#12 SUB2009-00141

MURRAY BRIGHAM PLACE SUBDIVISION

MURRAY BRIGHAM PLACE SUBDIVISION

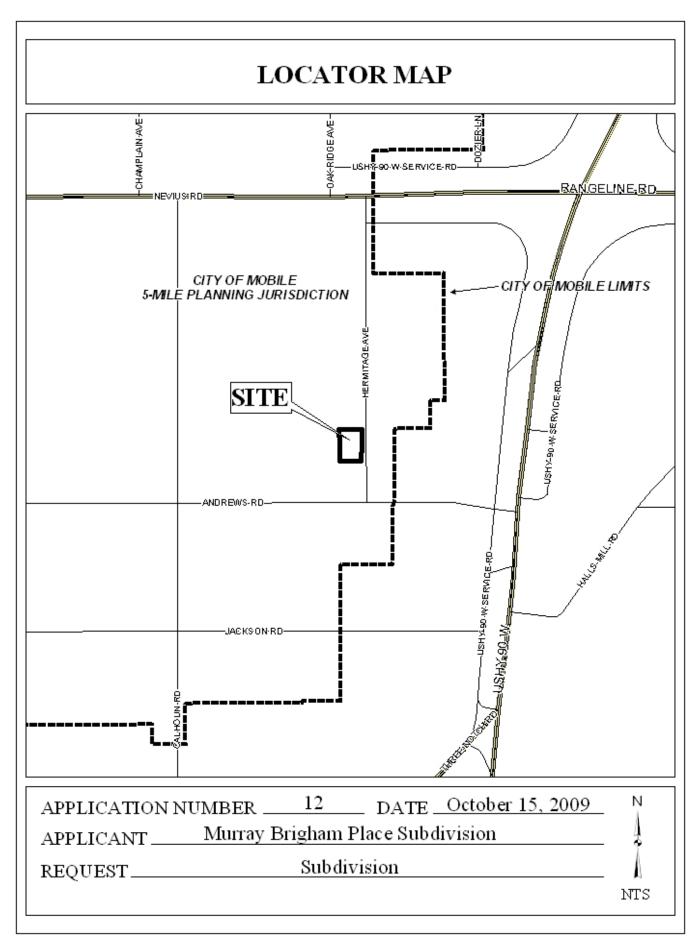
The plat illustrates the proposed 2-lot, $0.3\pm$ acre subdivision which is located on the West side of Hermitage Avenue, 150' North of Andrews Road. The applicant states that the subdivision is served by public water and public sanitary sewer.

The site fronts Hermitage Avenue, which as illustrated has an existing 50-foot right-of-way. Hermitage Avenue appears not to have curb and gutter, therefore, a 60-foot right-of-way is required. It should be noted that the dedication of sufficient right-of-way to provide 30-feet from the centerline of Hermitage Avenue may reduce the overall square footage of each lot under the minimum square footage requirements of the Subdivision Regulations, thus a waiver of Section V.D.2. would be necessary. The subdivision and reduction of lot size would have little or no impact as both "lots" are already developed.

As a means of access management, each lot should be limited to one curb cut with the size, location, and design to be approved by County Engineering and in conformance with AASHTO standards as indicated on the preliminary plat and should be retained on the final plat, if approved.

The geographic area defined by the city of Mobile and its planning jurisdiction, including this site, may contain Federally-listed threatened or endangered species as well as protected non-game species. Thus, as noted on the plat, development of the site must be undertaken in compliance with all local, state and Federal regulations regarding endangered, threatened or otherwise protected species.

The site is located in the county. Therefore, the note should be retained on the final plat, if approved stating that any lots developed commercially and adjoin residentially developed property must provide a buffer, in compliance with Section V.A.8. of the Subdivision Regulations.

While the site is located in the county, as noted on the plat and should also appear on the final plat, compliance with the City of Mobile storm water and flood control ordinances will be required, and a letter from a licensed engineer certifying compliance with the City's storm water and flood control ordinances should be submitted to the Mobile County Engineering Department and the Planning Section of Mobile Urban Development prior to the issuance of any permits for new construction.

- 1) Dedication of sufficient right-of-way to provide 30-foot from the centerline of Hermitage Avenue;
- 2) Depiction of the 25-foot minimum building setback line along all public rights-of-way reflecting required dedication;

- 3) Revision of the lot size square footage to reflect dedication;
- 4) Retention of the note on the Final Plat stating that each lot is limited to one curb cut:

- 5) Retention of the note on the Final Plat stating that any lots which are developed commercially and adjoin residentially developed property must provide a buffer, in compliance with Section V.A.8. of the Subdivision Regulations;

- 6) Retention of the note on the Final Plat stating that the site must be developed in compliance with all local, state and Federal regulations regarding endangered, threatened or otherwise protected species; and

- 7) Retention of the note on the Final Plat stating that any new development will be designed to comply with the storm water detention and drainage facility requirements of the City of Mobile storm water and flood control ordinances, and requiring submission of certification from a licensed engineer certifying that the design complies with the storm water detention and drainage facility requirements of the City of Mobile storm water and flood control ordinances prior to the issuance of any permits. Certification is to be submitted to the Planning Section of Urban Development and County Engineering.
